# 51 MELCHER

FORT POINT, SOUTH BOSTON, MA

FORT POINT CHANNEL LANDMARKS DISTRICT

09.21.2022

EXISTING ROOF PLAN

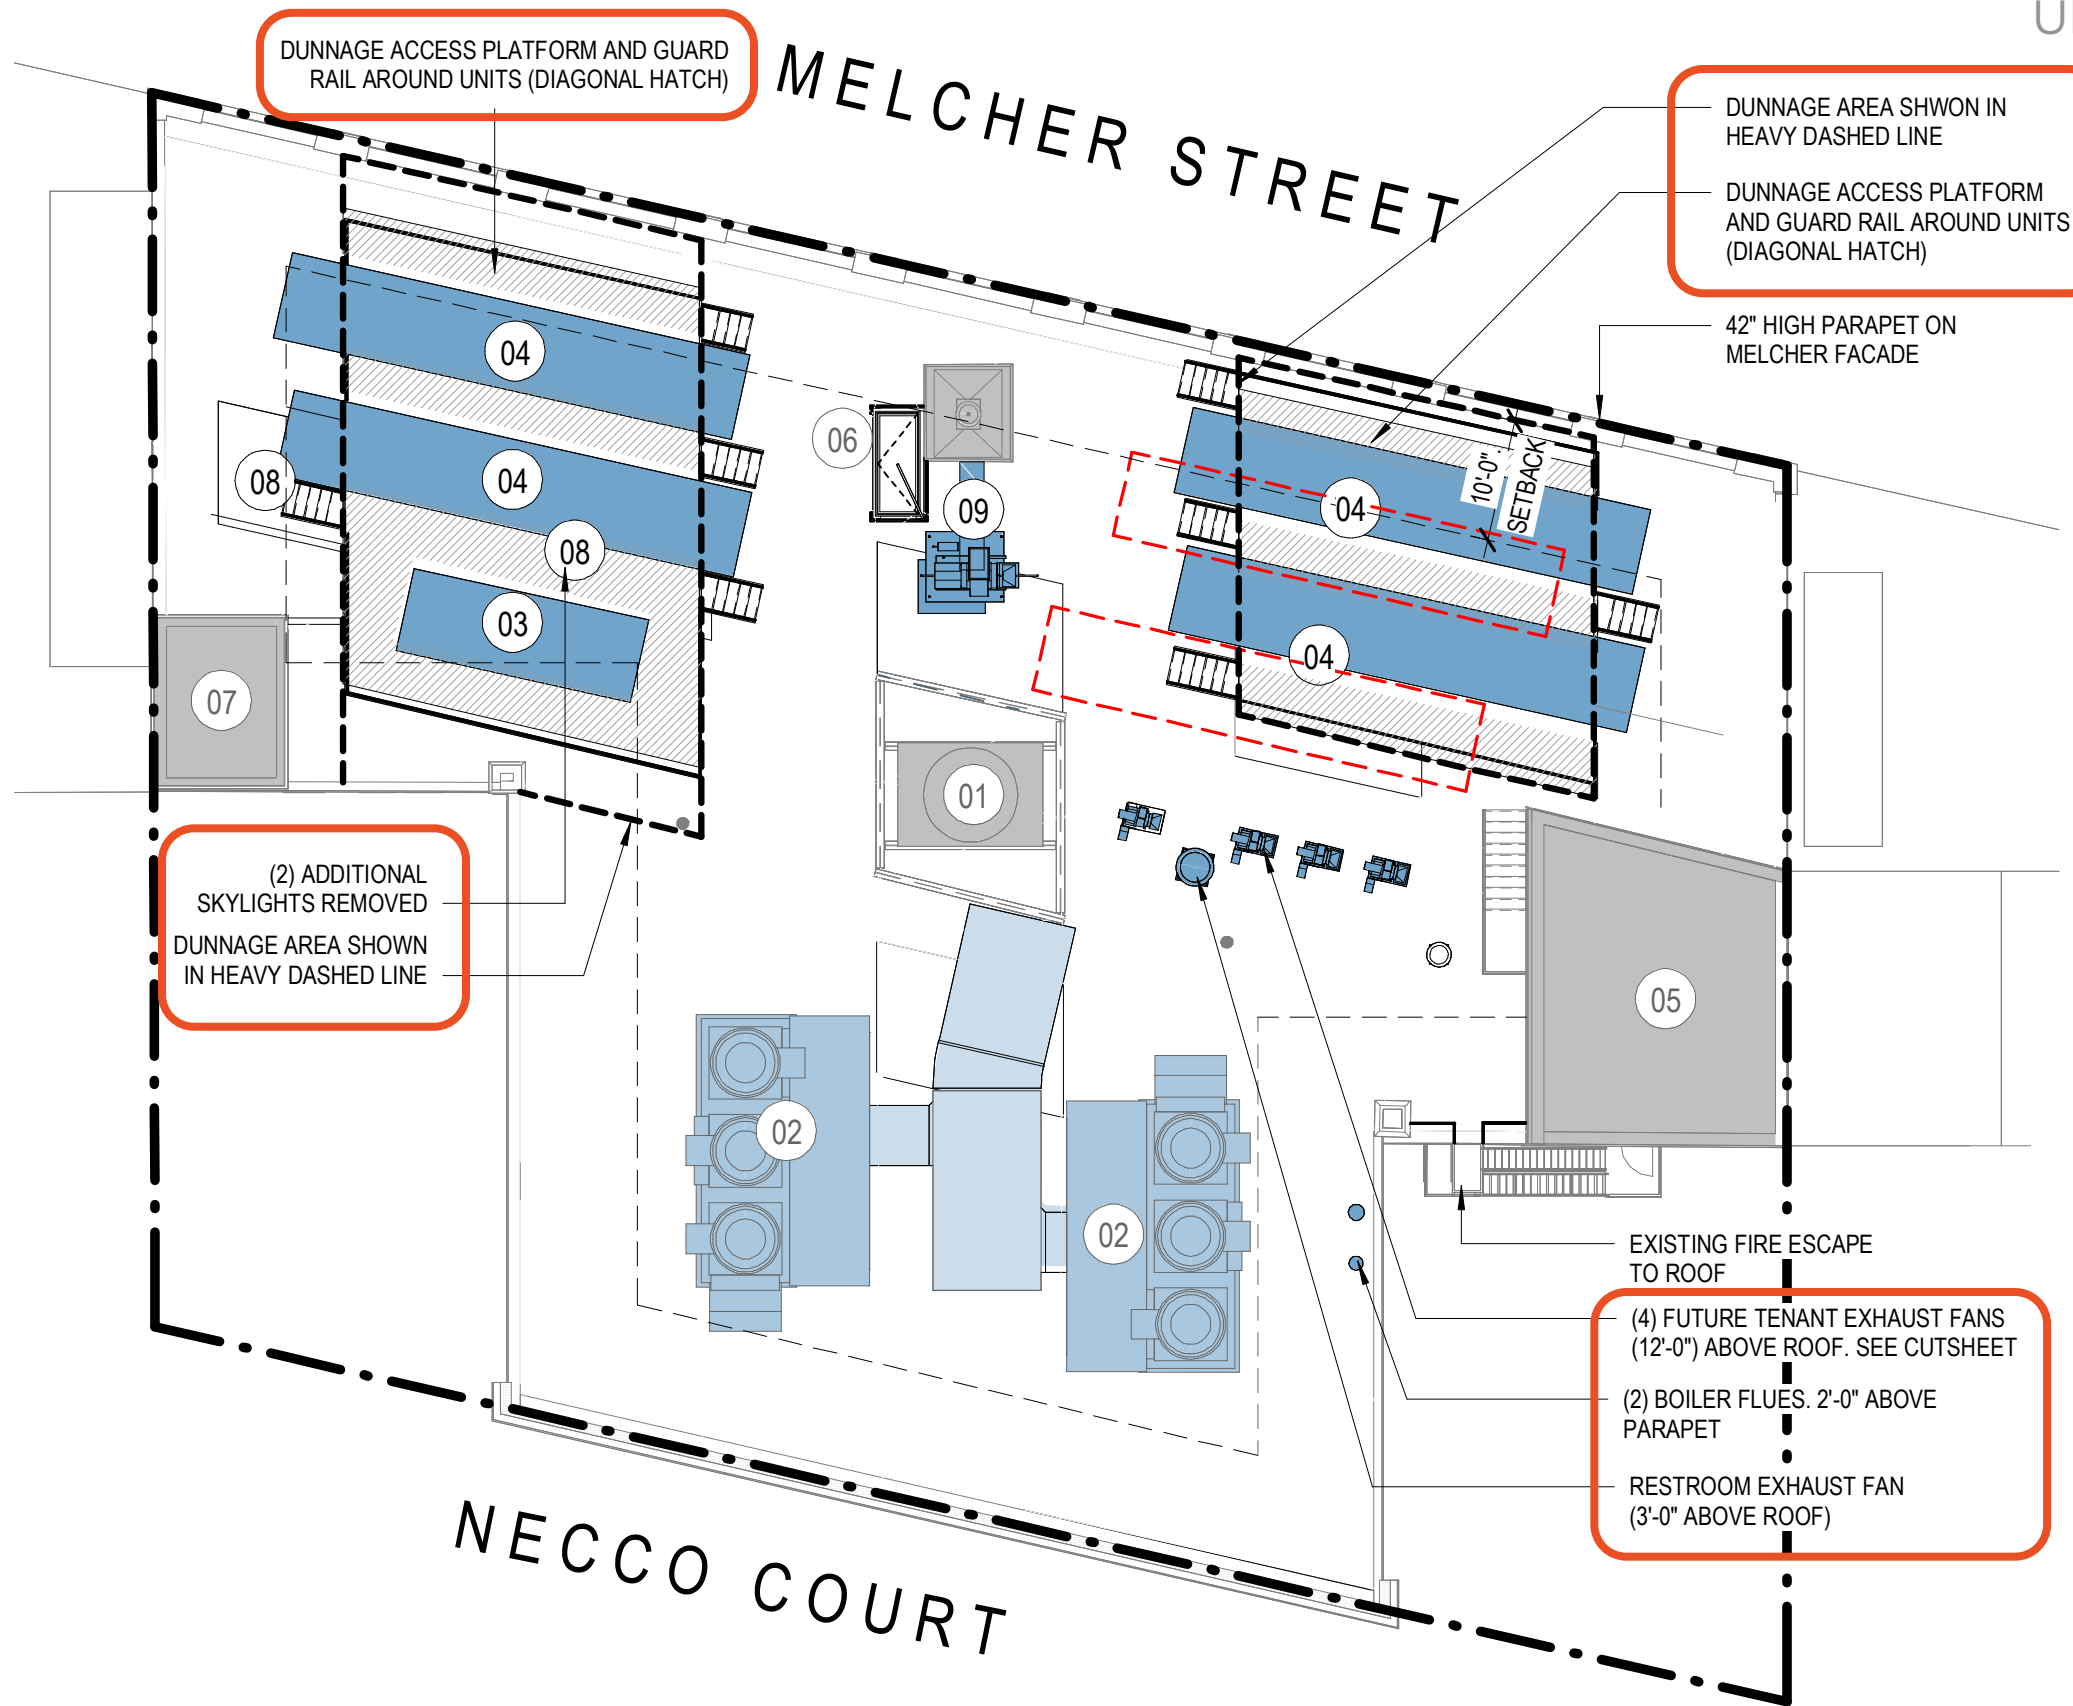
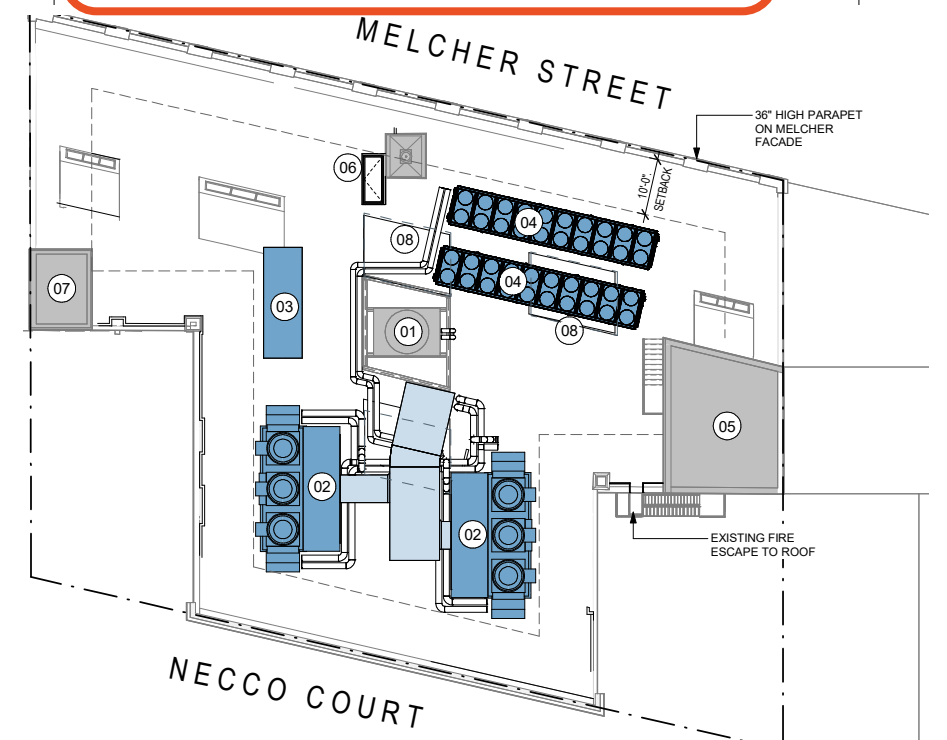
Mechanical exhaust units cannot be moved closer to center, due to constraint at cooling tower and required clearances. Refer to updated plan in presentation.

- **(2) CHILLERS REMOVED. (4) AIR SOURCE HEAT PUMPS ADDED.**  
**REASON:** IN CONJUNCTION WITH THE IGBC AND ARTICLE 37 THE EQUIPMENT IS REQUIRED TO ACHIEVE 97% REDUCTION IN FOSSIL FUELS AND TO ALIGN ITSELF WITH THE NEW SUSTAINABILITY STANDARDS OF THE CITY.
- STEEL DUNNAGE AND PLATFORMS ADDED TO ACCOUNT FOR THE (4) NEW AIR SOURCE HEAT PUMPS.
- **(4) TENANT EXHAUST FANS ADDED.**  
**REASON:** TO ALLOW FOR TENANT FLEXIBILITY AND LIMIT FUTURE IMPACTS.
- **(1) STAIR PRESSURIZATION FAN AND (2) SMALL EXHAUST FANS**  
**REASON:** REPLACEMENT OF EXISTING AND REQUIRED FOR BUILDING OPERATION.

RECONFIGURED LOADING DOCK  
 PROPOSED EQUIPMENT LOWERED TO GRADE

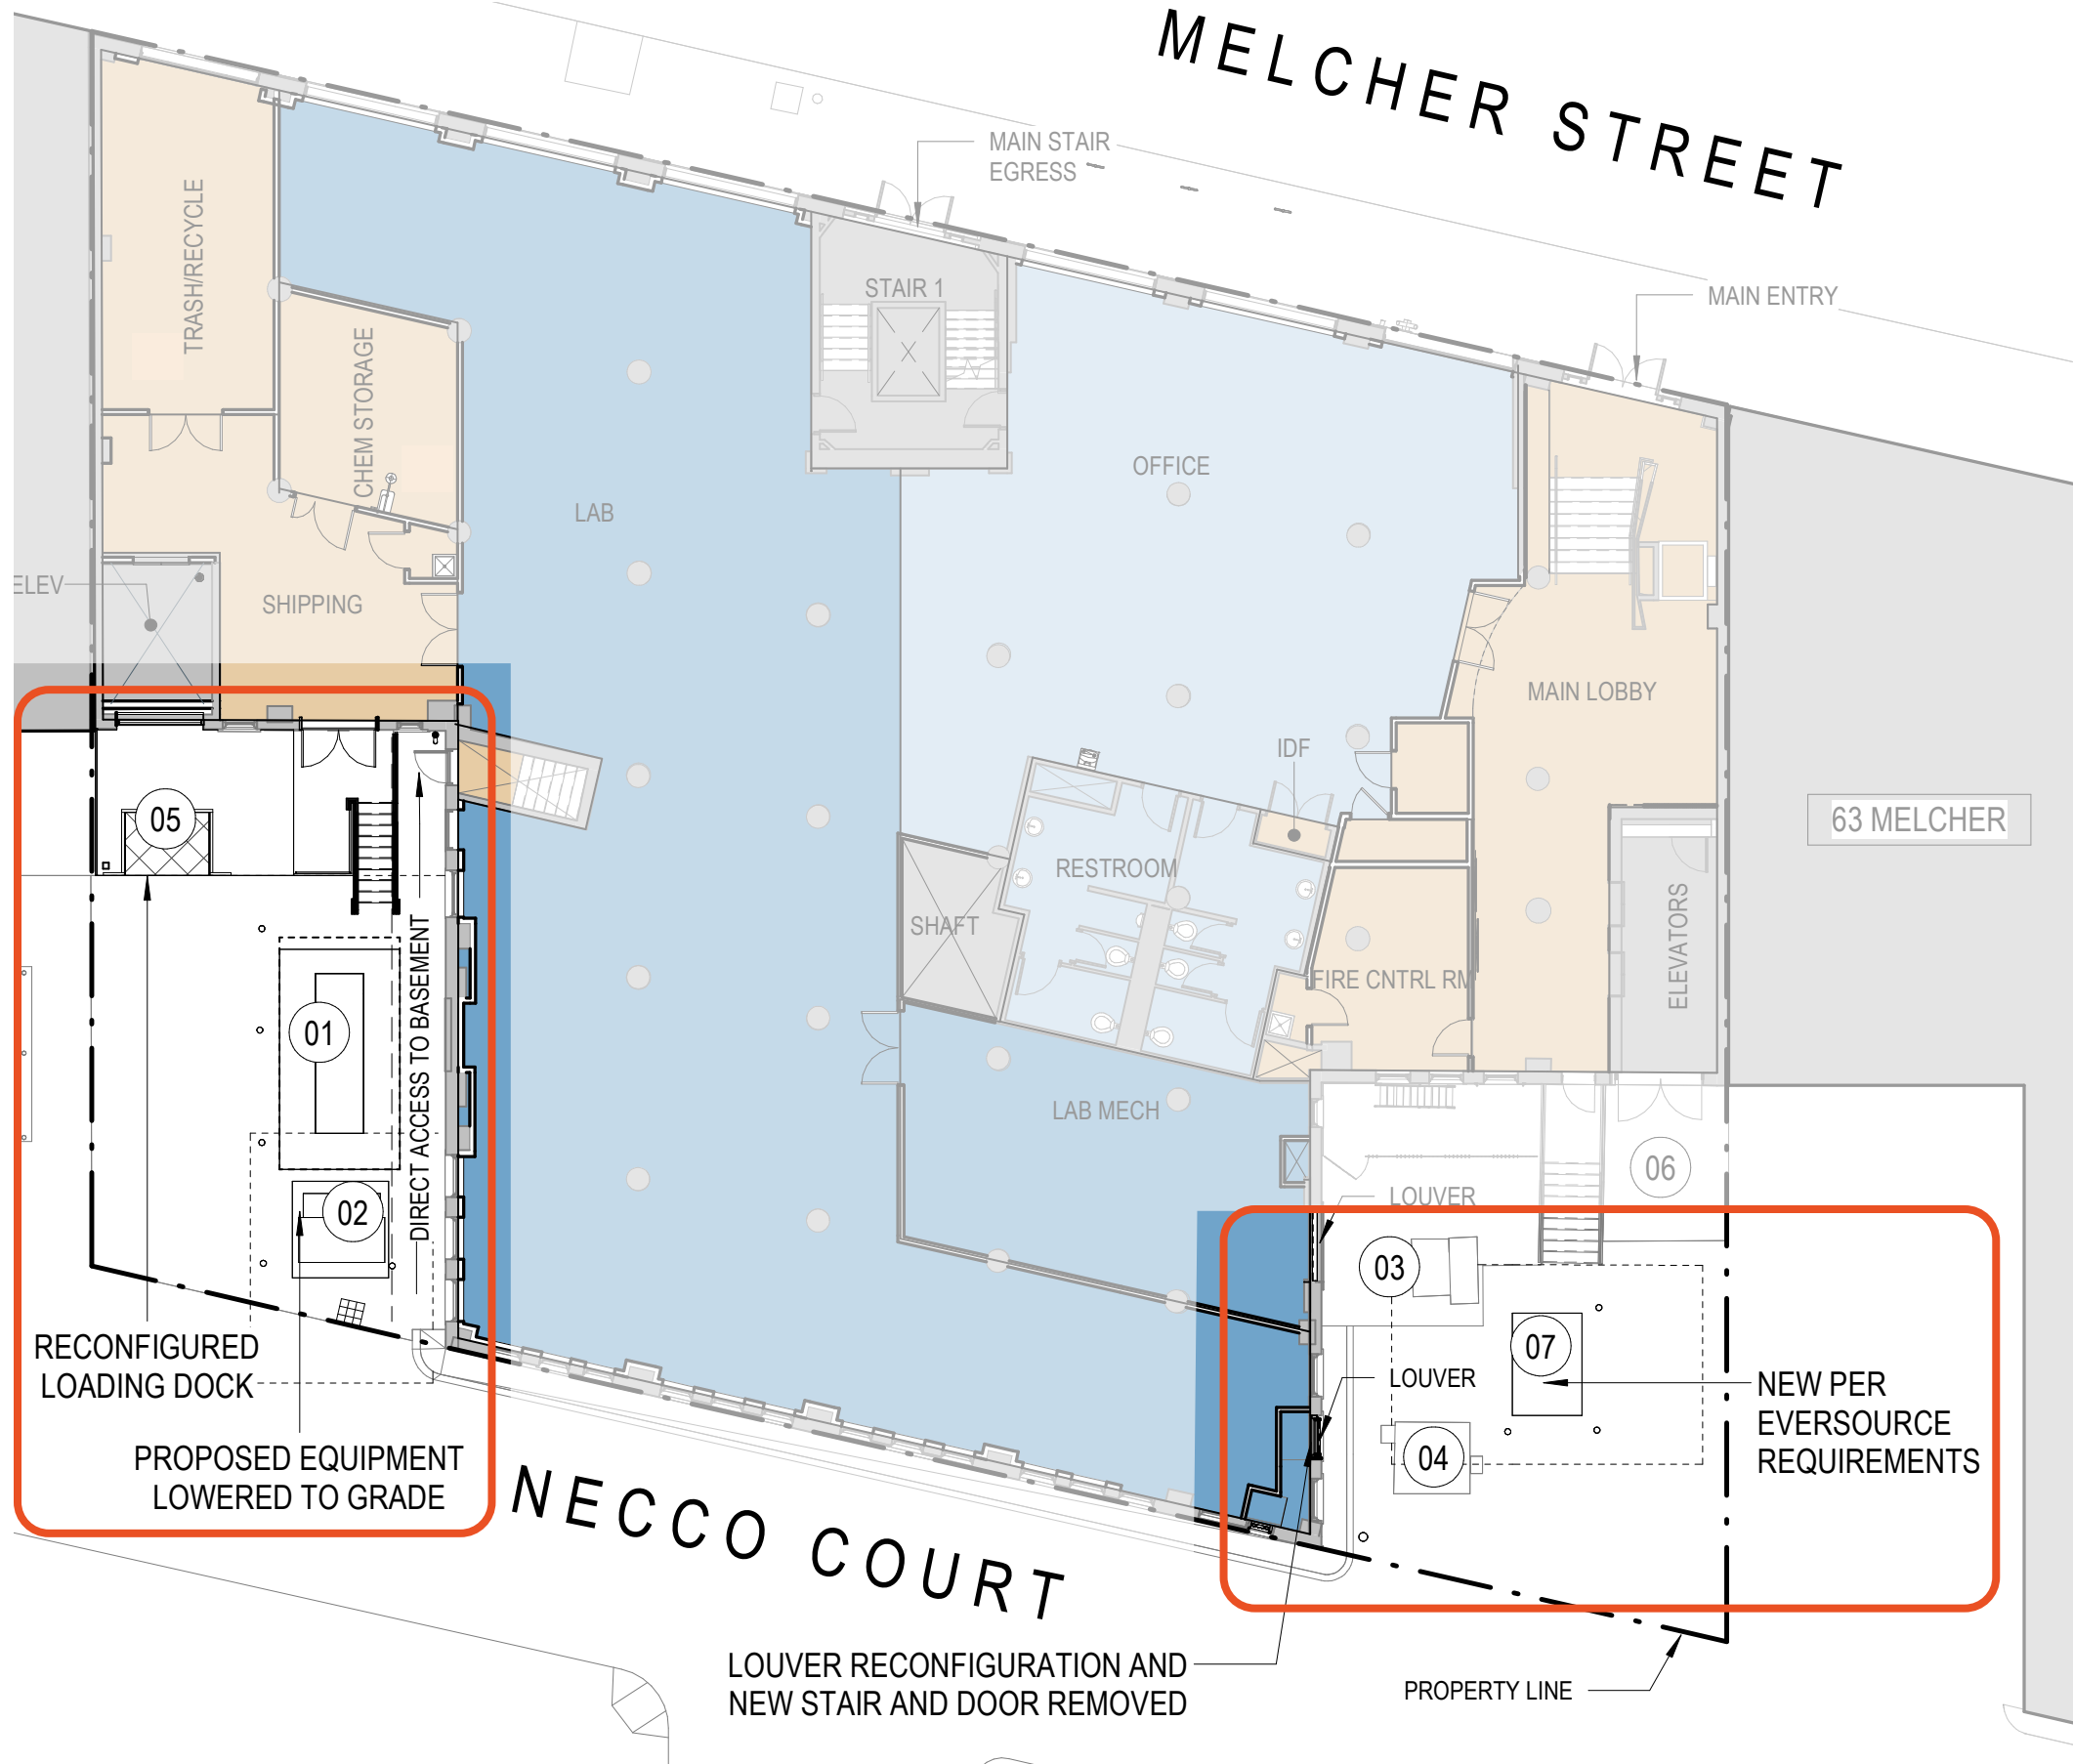
- **(1) ELECTRICAL SWITCH ADDED.**  
REASON: PER EVERSOURCE COORDINATION.
- **PROPOSED GENERATOR AND TRANSFORMER LOWERED.**  
REASON: DUE TO COORDINATION WITH BPDA/EVERSOURCE.

NEW PER EVERSOURCE REQUIREMENTS

Generator was lowered to grade and the team is utilizing a flood shield protection approach in lieu of raising. Transformer and Switch no longer needs to be raised per conversations with Eversource.

UPDATED PROPOSED PLAN - SOUTH DOCK

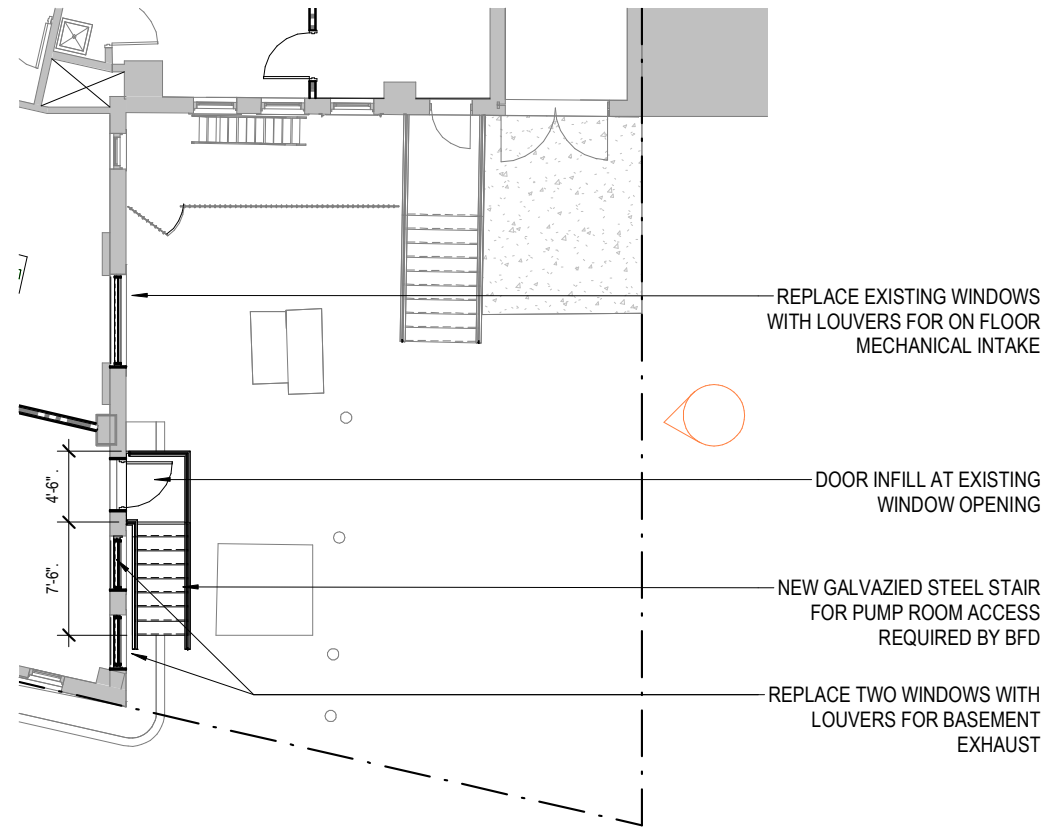
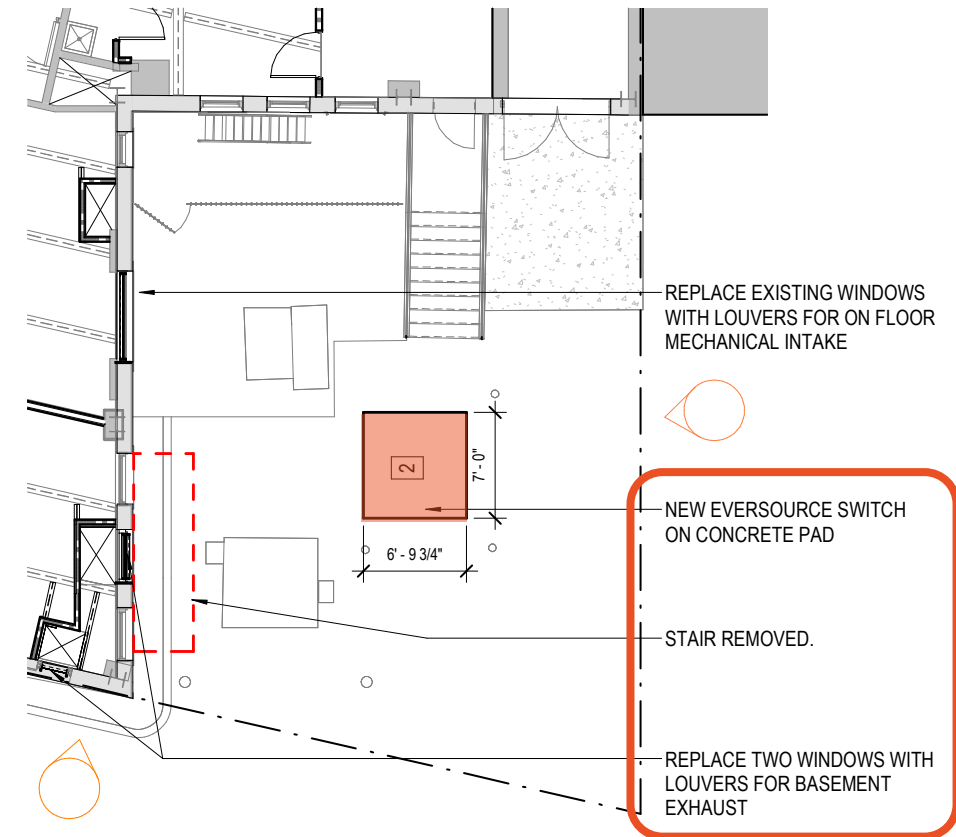
LOUVER RECONFIGURATION AND NEW STAIR AND DOOR REMOVED
